From: Amy Thompson
To: [Ramirez, Elaine](#)
Cc: [REDACTED]
Subject: BOA Case # C15-2020-0020 _ Resident Objection
Date: Monday, May 11, 2020 12:20:13 AM
Attachments: [Case Number C15-2020-0020 Public Comment Objection Thompson.pdf](#)
[1401 E 3RD ST Site Plan.pdf](#)

Public Comment Re: Case Number C15-2020-0020 (1401 East 3rd St.)

Submitted by: Amy Thompson, Adjacent Property owner at 1402 East 2nd St.; tel: 512-659-7666

Position: I **STRONGLY OBJECT** to the proposed variance (see comments below)

1 Site Plan

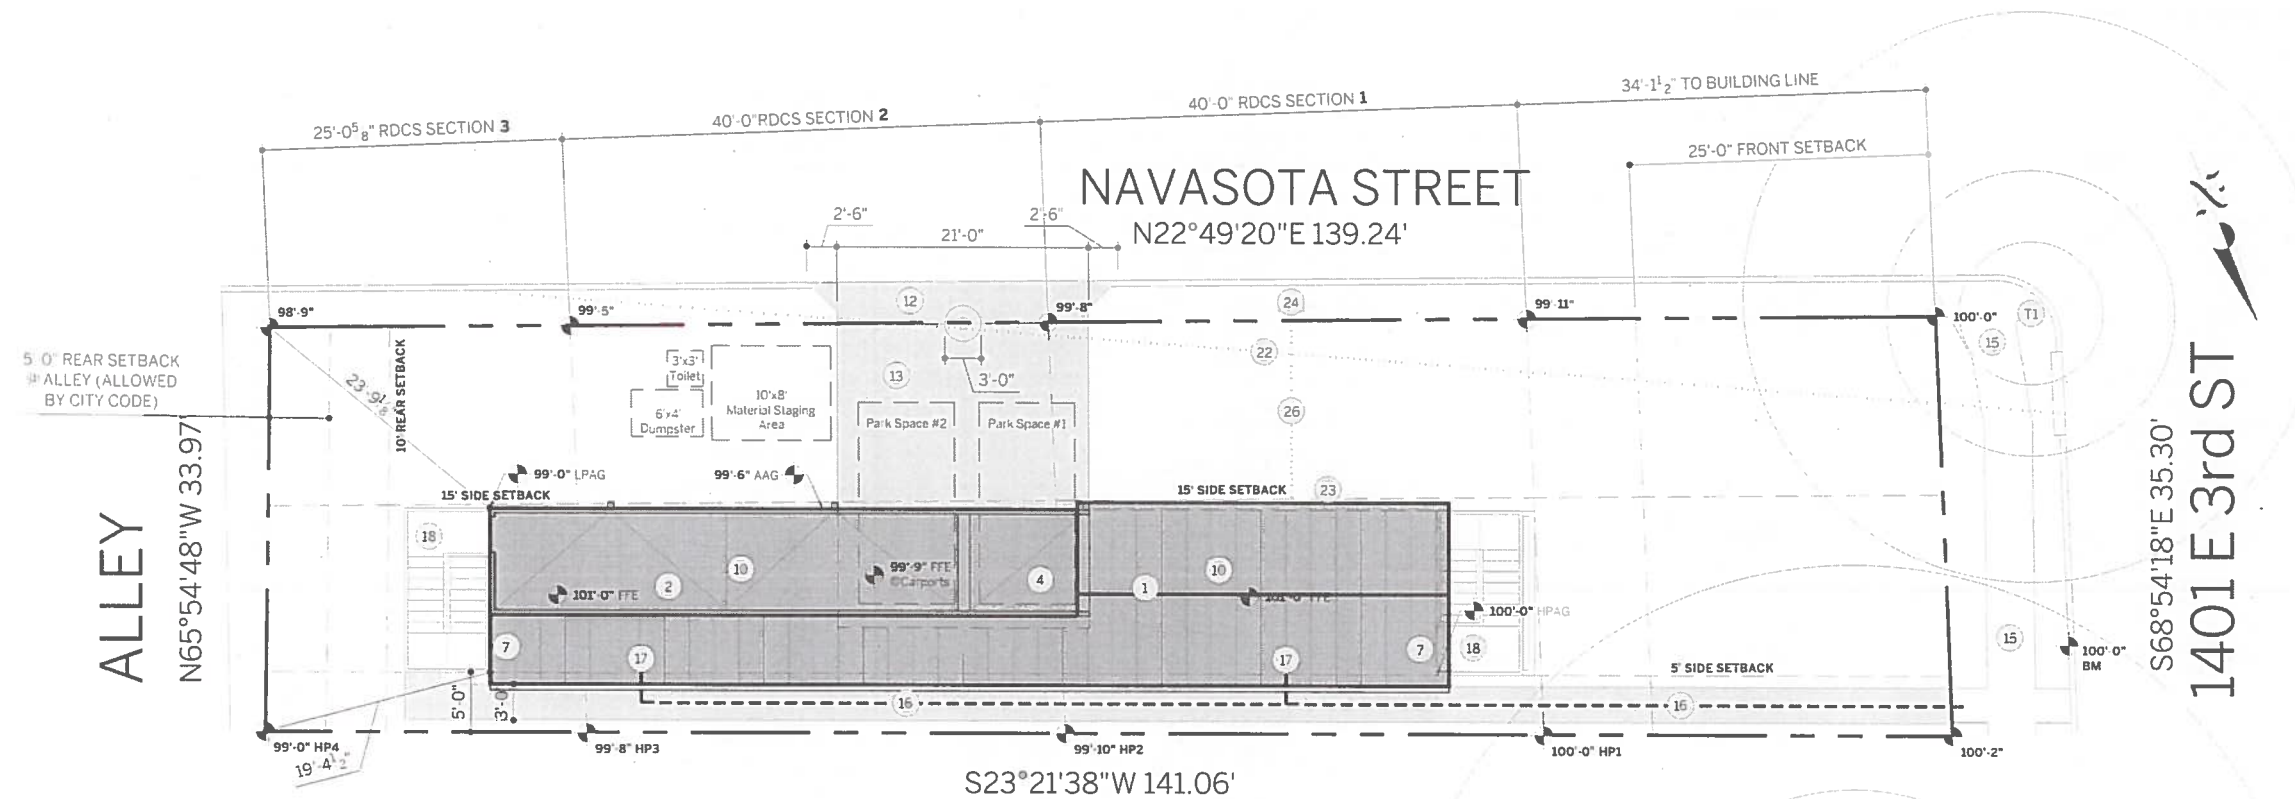
The site plan (attached) confirmed that the plan was approved in violation of the code, but no immediate justification was apparent. Once the foundation was poured in violation of the code, I sent another inquiry. The response by City staff to this inquiry was dismissive, despite the clear violation and

1 Elevation, Bldg 1, Front
Scale 1/8" = 1'-0" @ 11x17
Scale 1/4" = 1'-0" @ 24x36

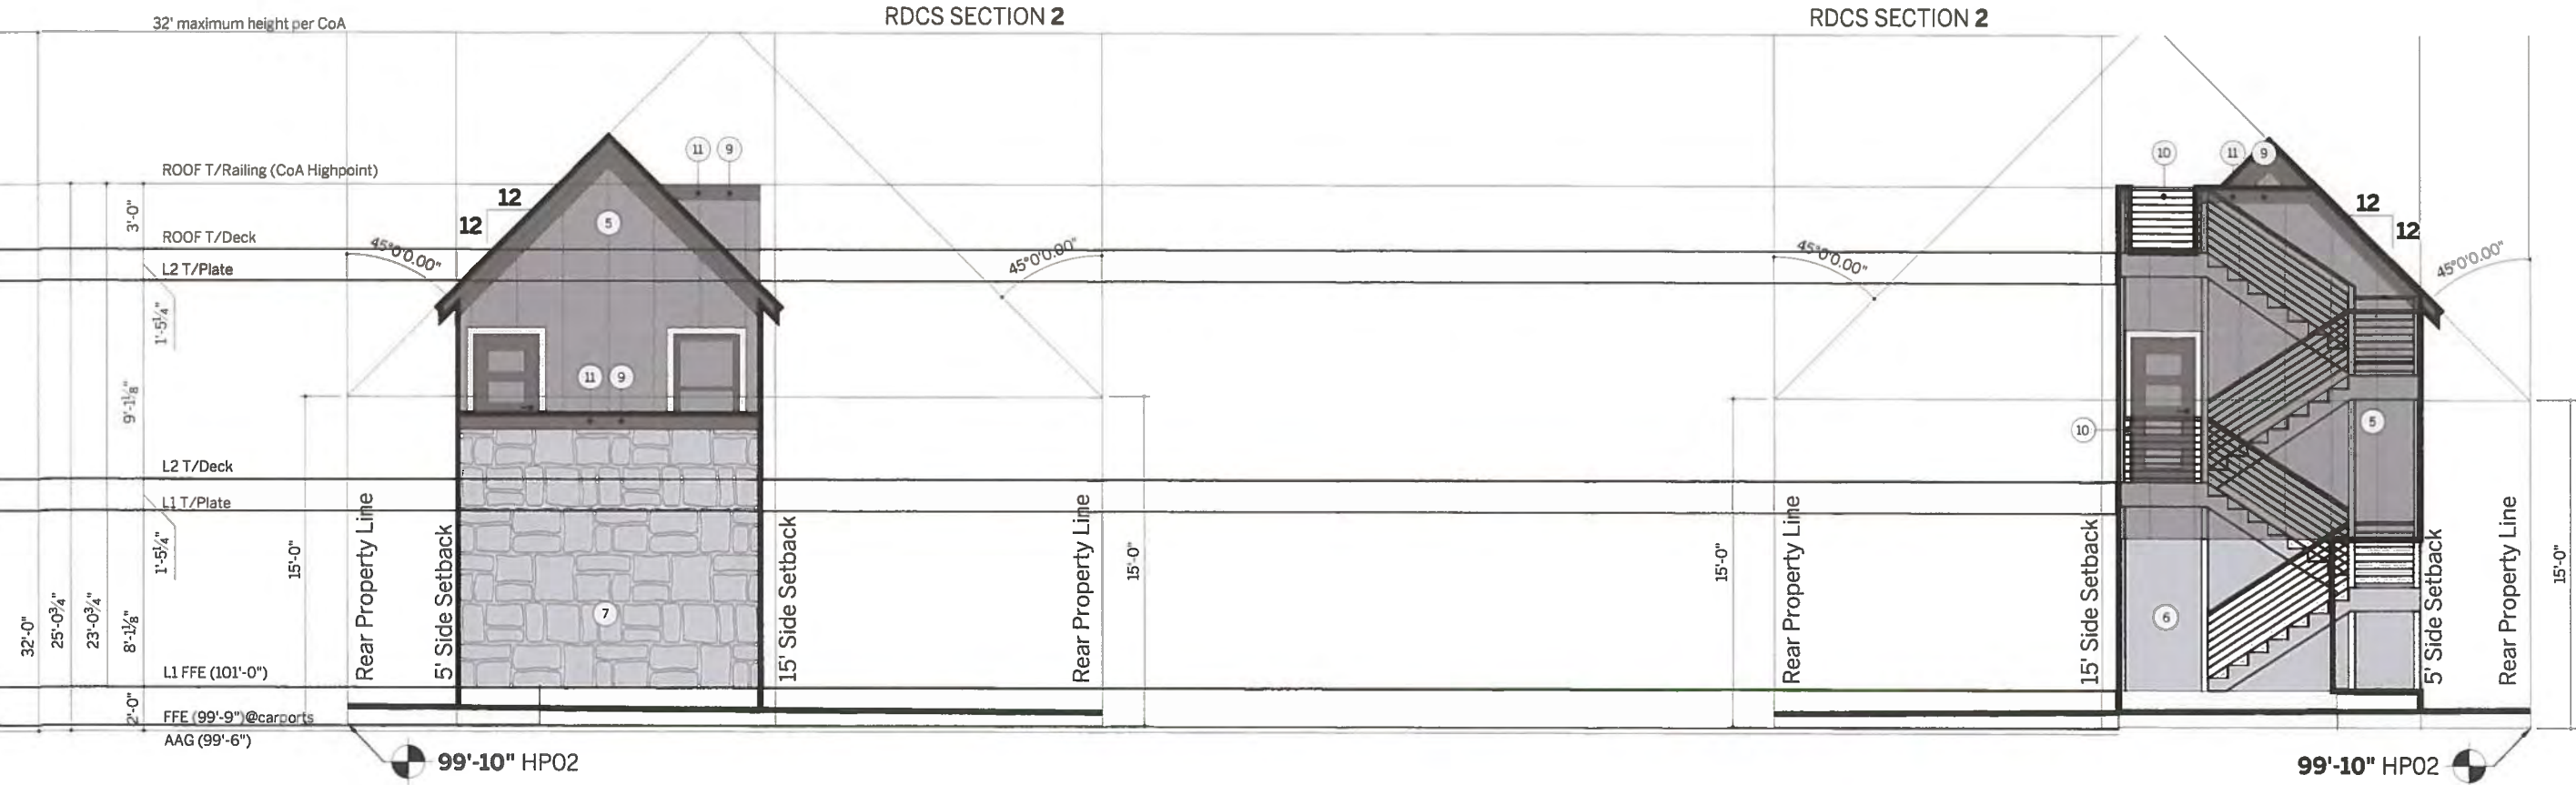
This is an approved plan and there is a projection into the 5 foot setback. This is a common concern, but the code does allow for eaves and other incidentals to project 2 ft. into any setback, LDC 25-2-513 B. If you look at sheet A201, you can see the elevation view of the proposed residence. On this elevation, you can see the footprint of the building stops at the 5 ft. setback and the eaves project into the setback. Again this is an allowed and common design.
